PROPOSED DIAGRAMS
(and associated text update in spec)

PROPOSED DIAGRAMS
(and associated text update in spec)

Quad Host 4x4; Configurable Network Silicon 1x16 / 2x8 / 4x4

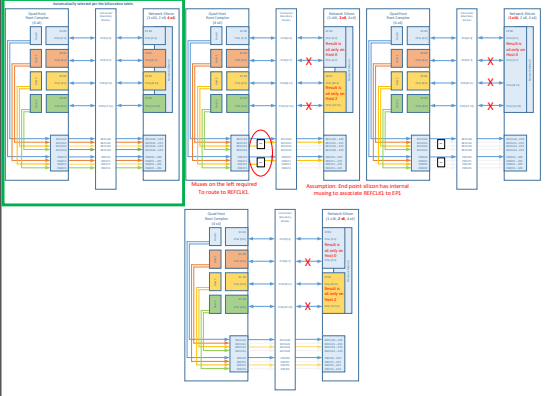
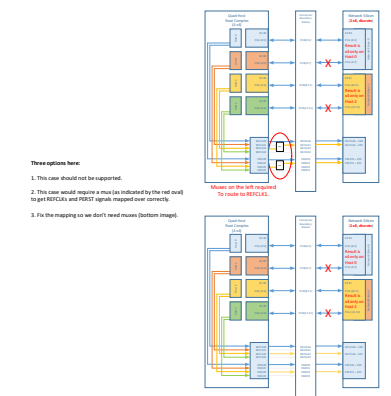
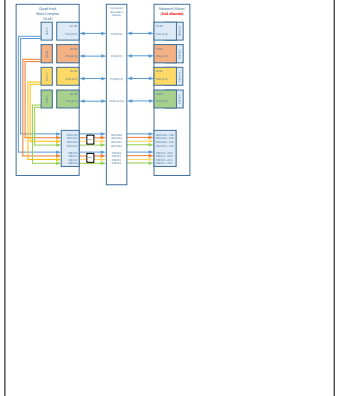
- These options here:
1. This case should not be supported.
 2. This case would require a mux (as indicated by the red oval) to get REFCLKs and PREST signals, respect over correct.
 3. Fix the mapping so we don't need muxes (bottom image).

PCIe Present and Bifurcation Control Pins (Baseboard **Controlled** BIF[0:2]#)

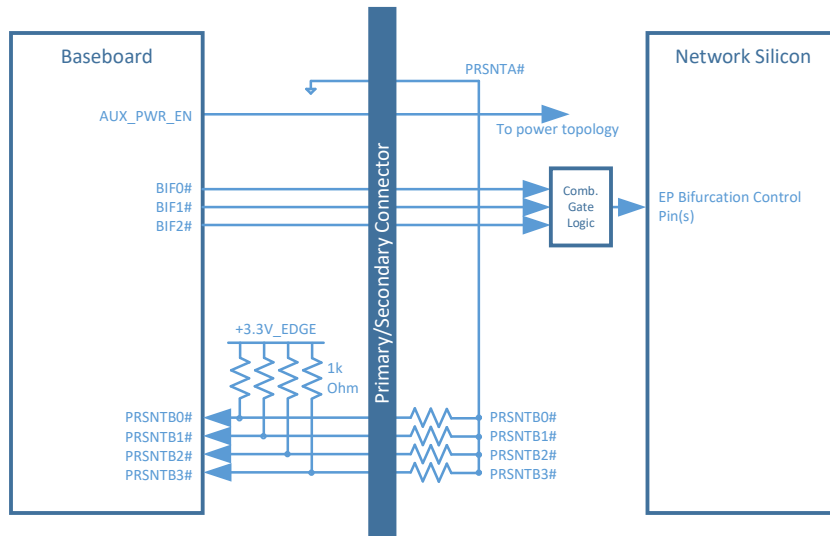
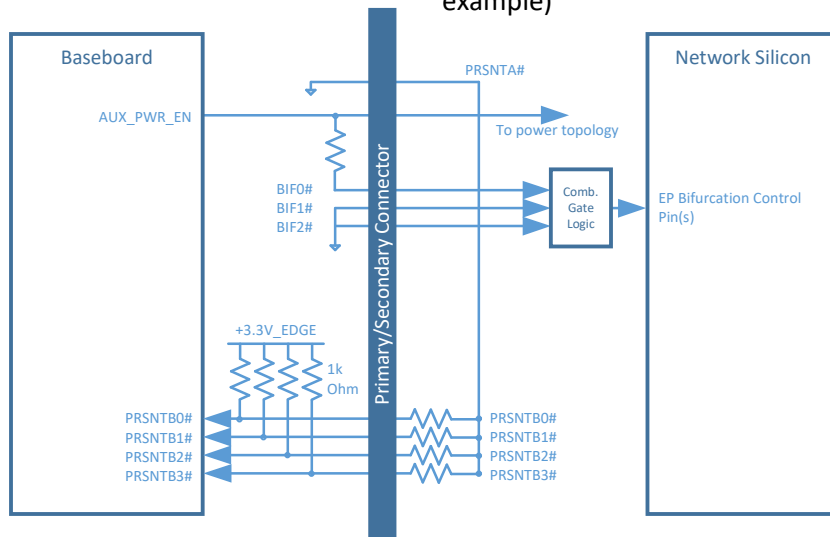
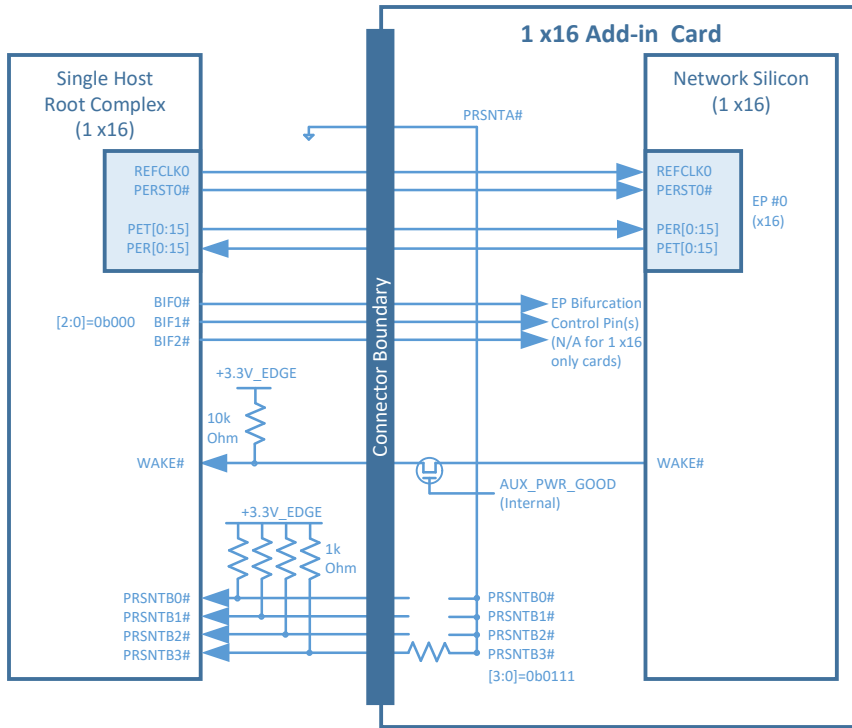
Updated 20180409a-TN – Diagram copied into the 0v73 specification
- added static BIF configuration (forced by baseboard, not configurable). BIF high values tied to AUX_PWR_EN.

Single Host (1 x16) and 1x16 Add-in card

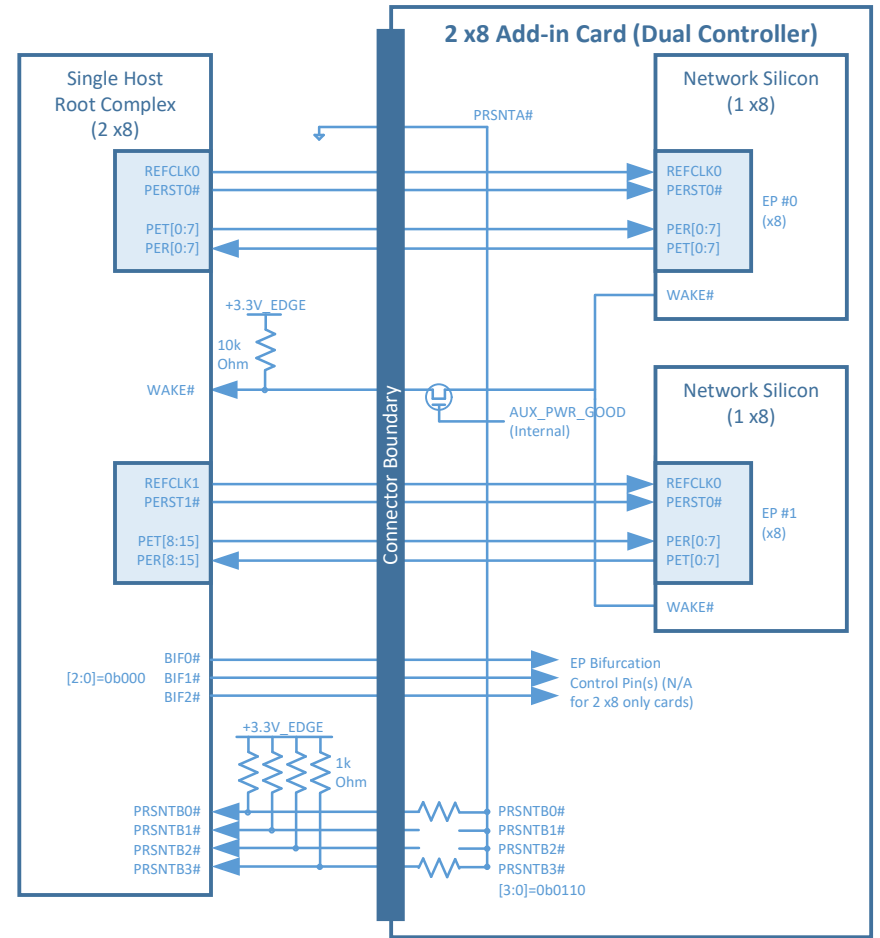
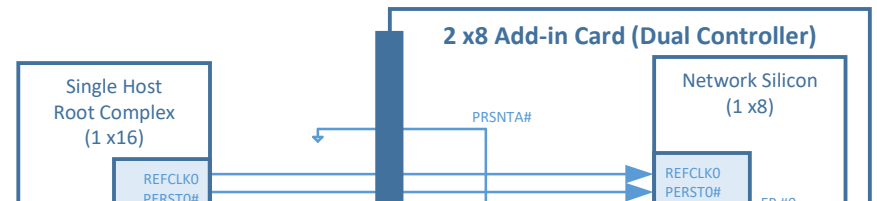
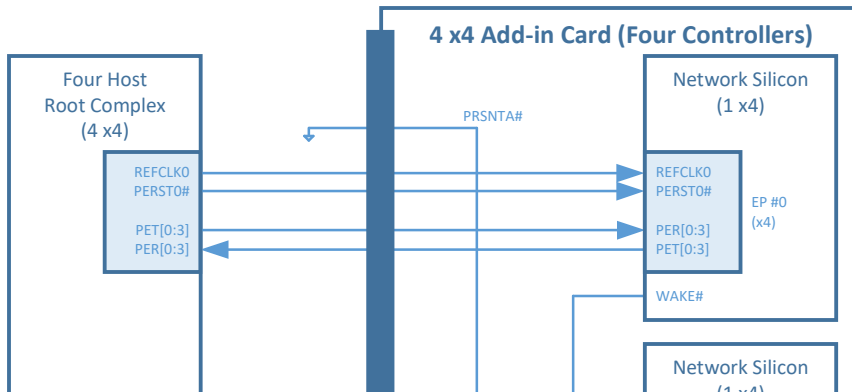
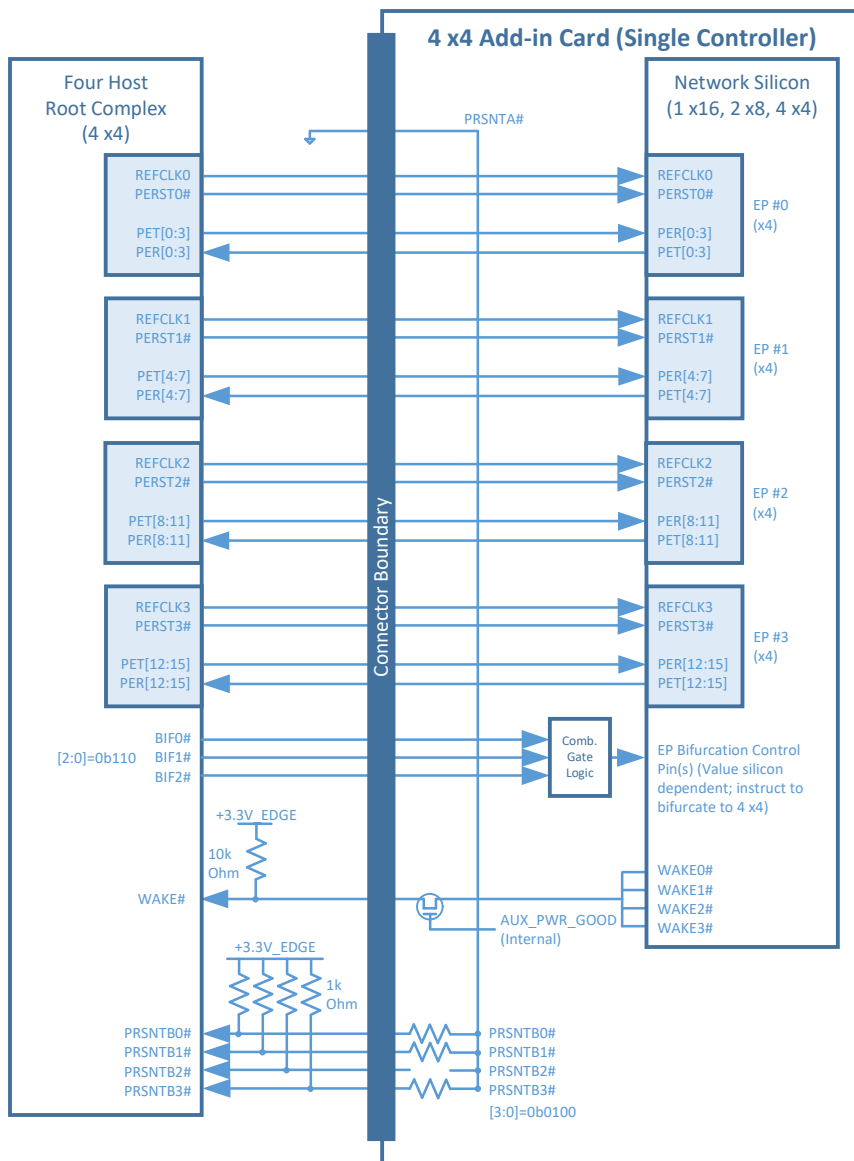
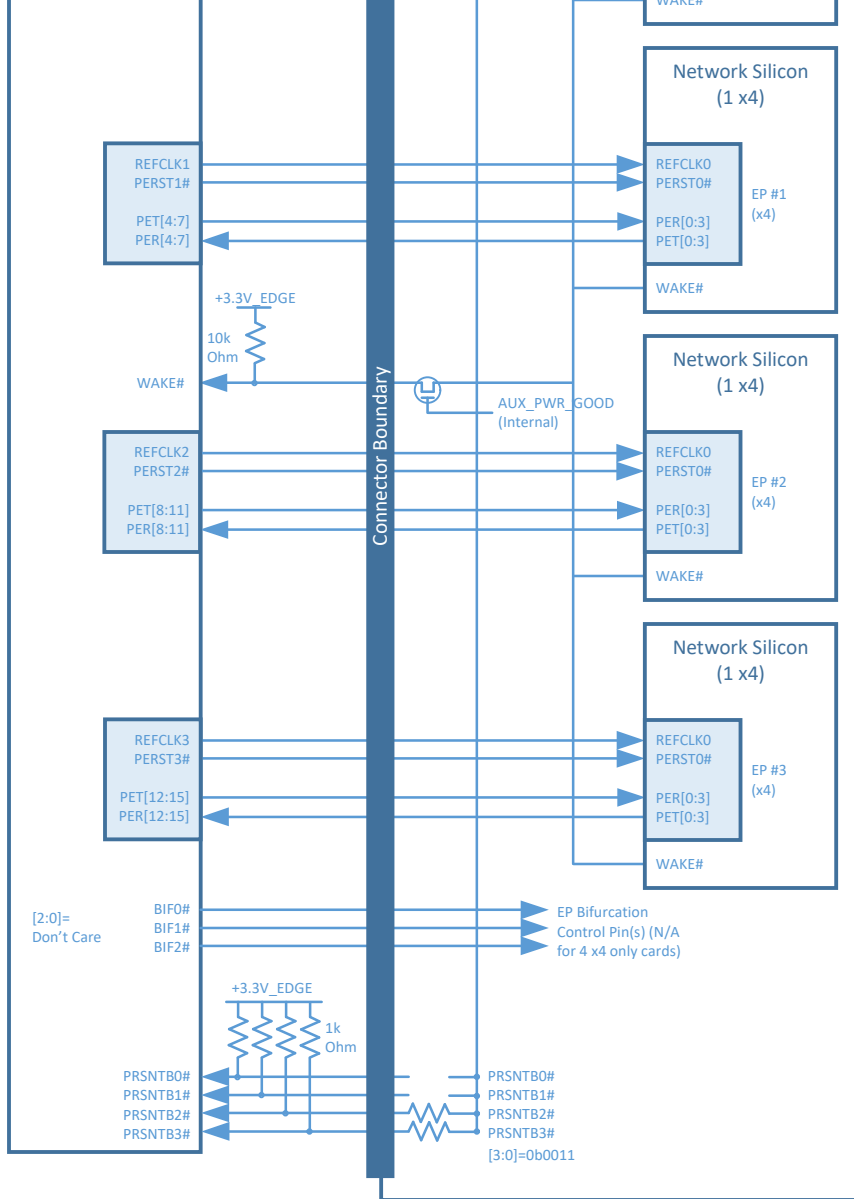
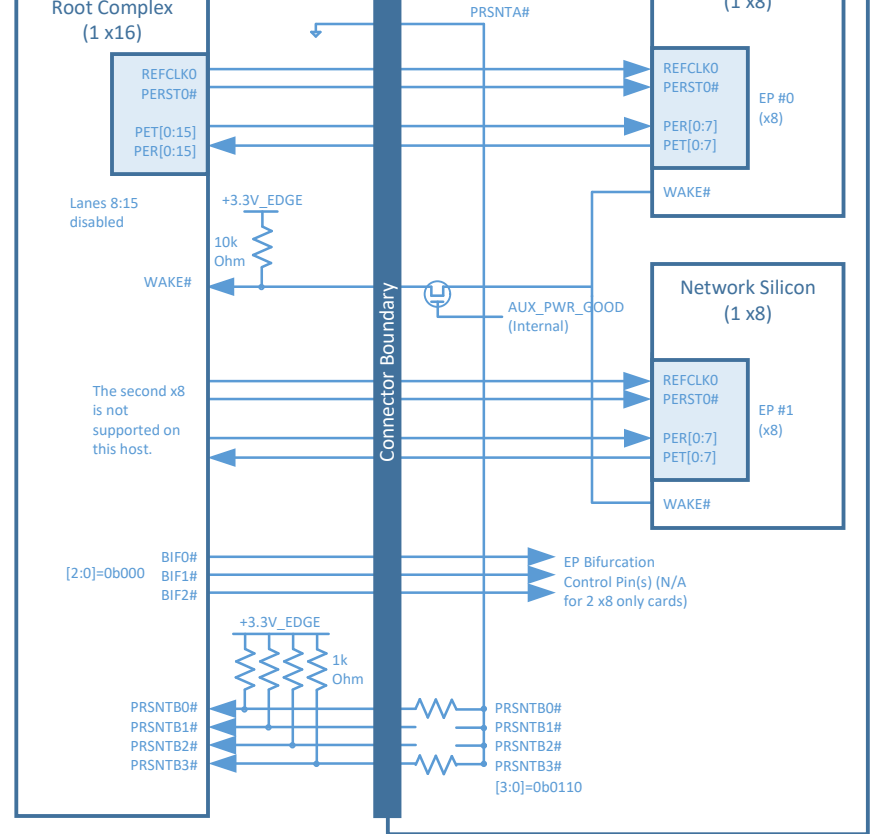
Updated 20180409a-TN – Diagram copied into the 0v73 specification

- added WAKE# gating via the AUX_PWR_EN signal to prevent WAKE# assertion prior to D3 state

Updated 20180508b-TN – Diagrams copied into the 0v73 20180508b spec

- Changed WAKE# to being gated by an internal (on-card) AUX_PWR_GOOD signal instead of AUX_PWR_EN

Updated 20180508b-TN – Diagrams copied into the 0v73 20180508b spec

- Changed WAKE# to being gated by an internal (on-card) AUX_PWR_GOOD signal instead of AUX_PWR_EN

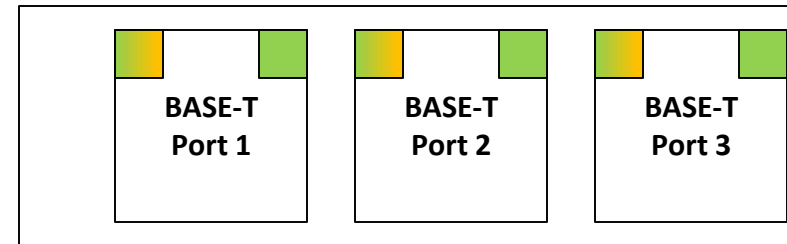
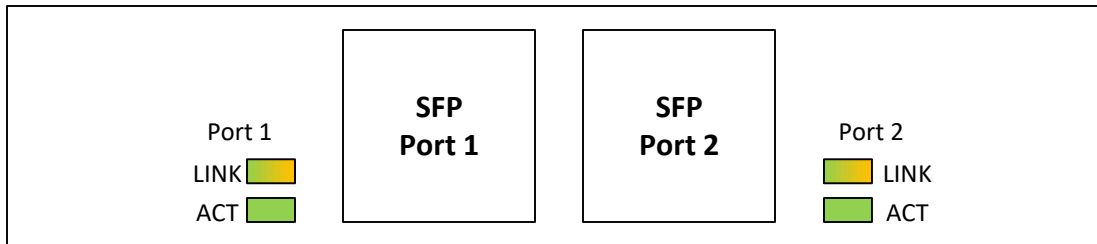
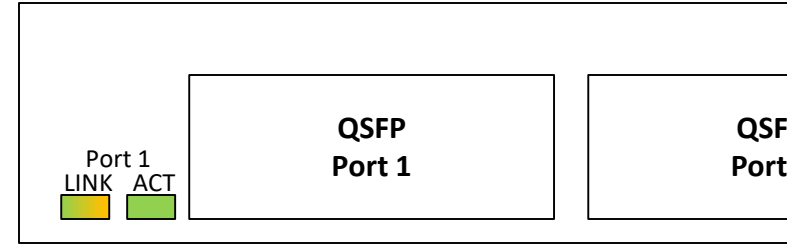
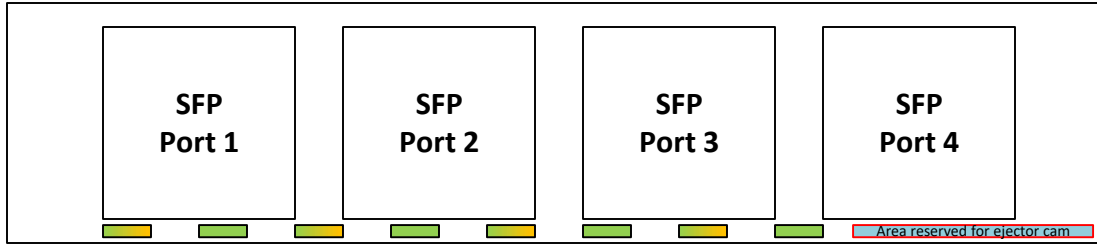
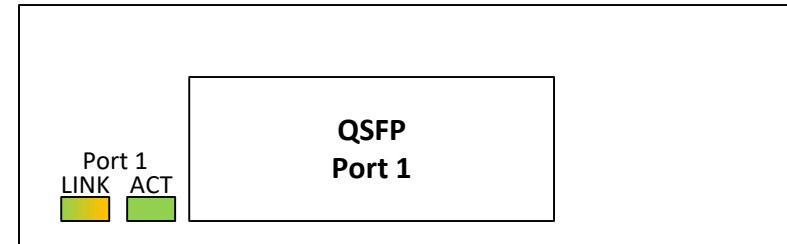
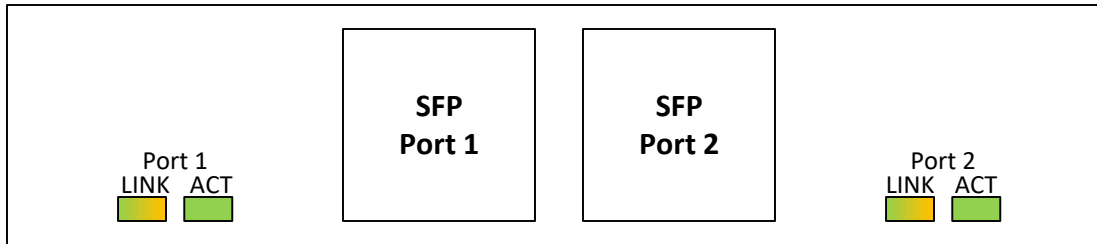
Updated 20180604d-TN – Diagrams copied into the 0v74 20180604d spec

- Fixed BIF values for all 5 examples.

Updated 20180712a – 4 x4 BIF pin values updated and copied into the 0v82 20180712c spec

MAC Address Label Example 4 – Quad Host, Single Port, Single Managed Controller

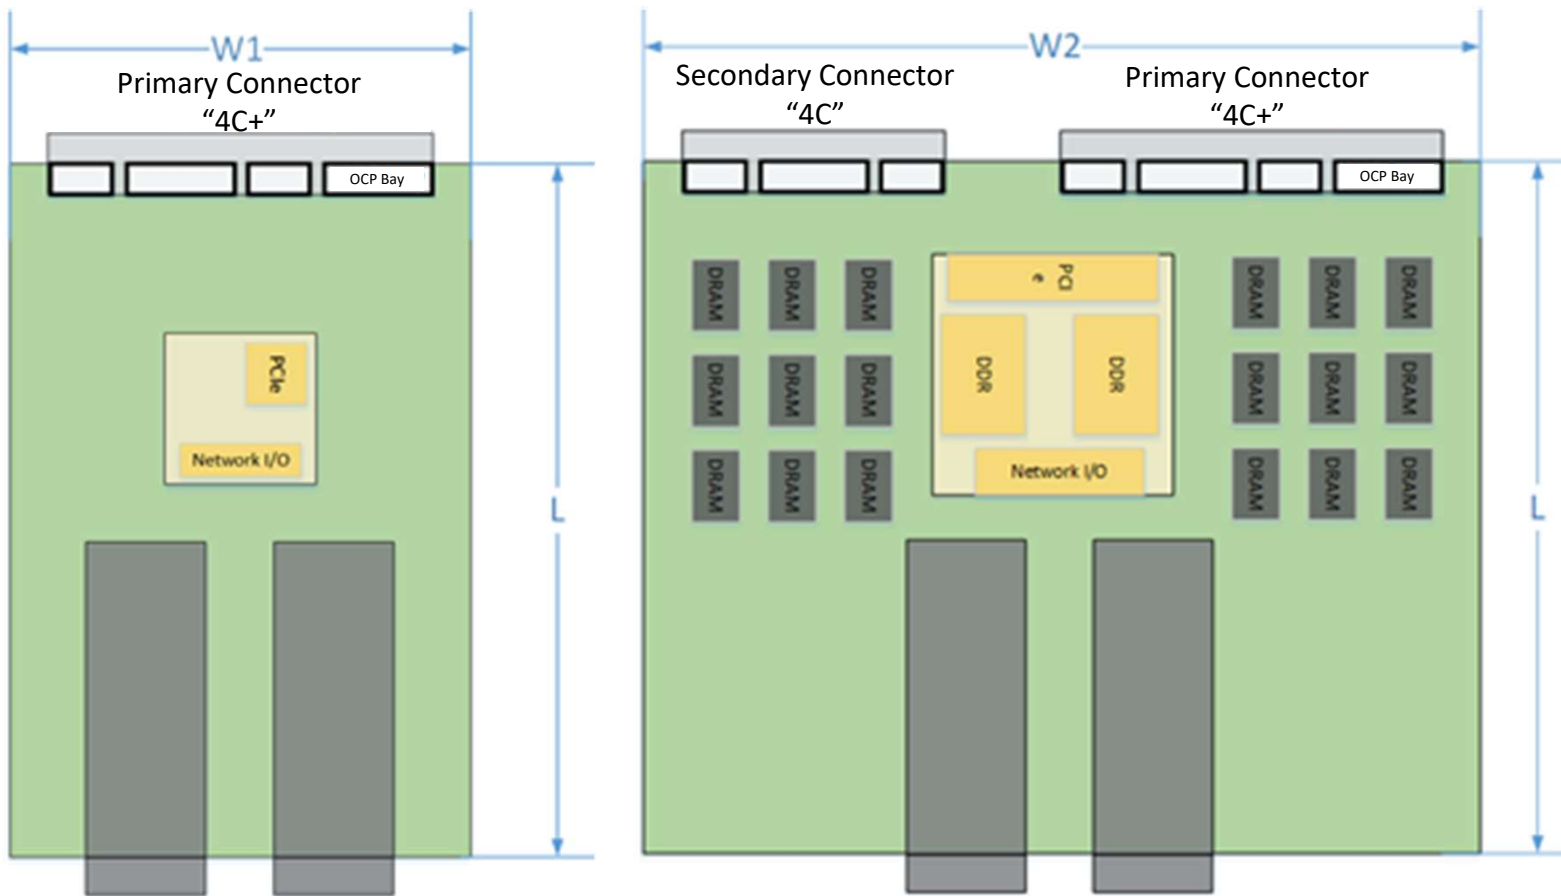
Change history:

0v84 20180910 – Changed MAC address element separator from periods “.” to colons “:”

Single Primary Connector

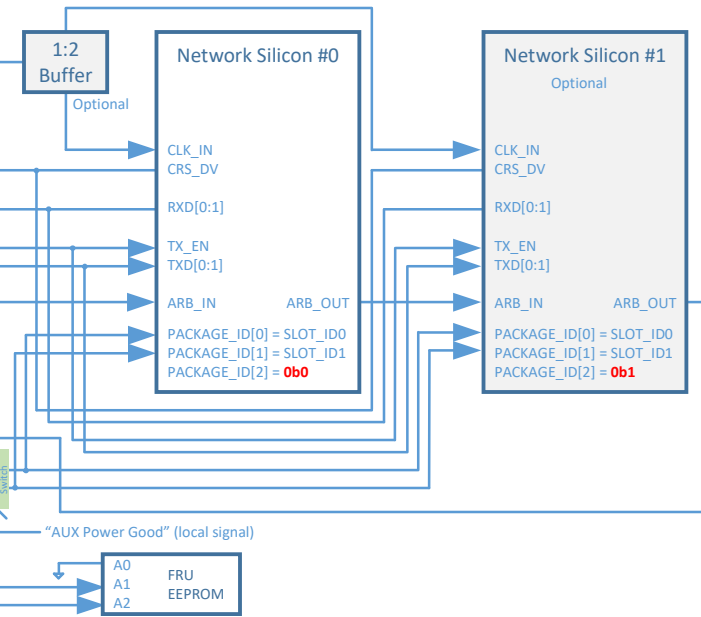
Updated 20180330-TN – Diagram copied into the 0v73 specification
 Updated 20180409-TN – Diagram copied into the 0v73 specification
 - Add quick switch that is tied to AUX_PWR_EN to prevent NC-SI leakage.

Updated 20180508b-TN – Diagrams copied into the 0v73 20180508b spec.
 - Update SLOT_ID[1:0] implementation.

Updated 20180515a-TN – Diagrams copied into the 0v73 20180508b spec.
 - Moved RBT isolation to baseboard side per OCP NIC 3.0 Working Session #18.
 - RBT isolators controlled by a signal called RBT_ISOLATE# on the baseboard. Implementation determined by baseboard vendor. Must connect bus only after NIC_PWR_GOOD=0b1 indication from AUX Power Mode onwards.

Updated 20180525a-TN – Diagrams copied into the 0v74 20180525b spec.
 - Update RBT Package ID[2:0] mapping as PackageID[2] – controller instance; PackageID[1:0] == SLOT_ID[1:0]

Updated 20180619a-TN – Diagrams copied into the 0v81 20180619a spec.
 - SLOT_ID[1:0] buffering now on NIC side; add FRU EEPROM to diagram for clarity.
